SS 783-WST Progressive Low Voltage Disconnect Parameter Update

57X vehicles built between July 1st, 2021 and February 5th, 2025.

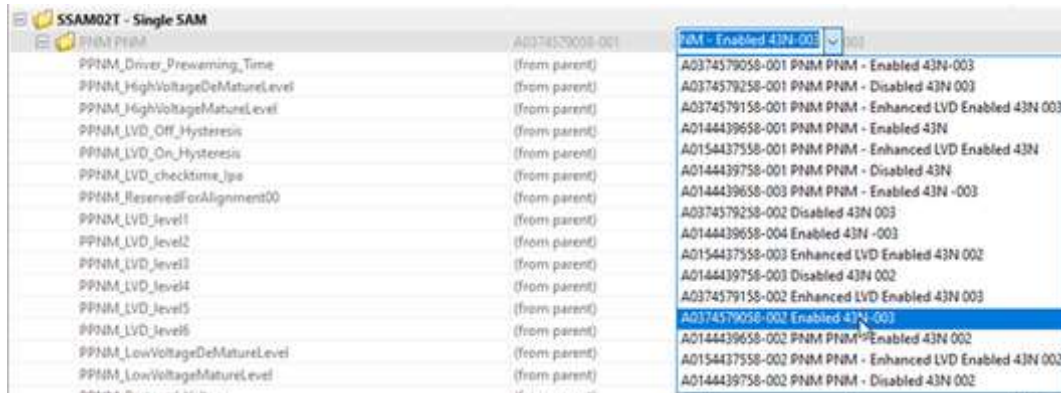
4. Expand the **SSAM02T**, expand the **PNM PNM** group.

5. Select the part number below in the drop down menu for the PNM group as shown below.

A0374579058-002 Enabled 43N-003

6. Verify the parameters are showing the correct values. If matching the values below, click **Send**.

PPNM_LVD_checktime_lpa = 10

PPNM_ReservedForAlignment00 = 0
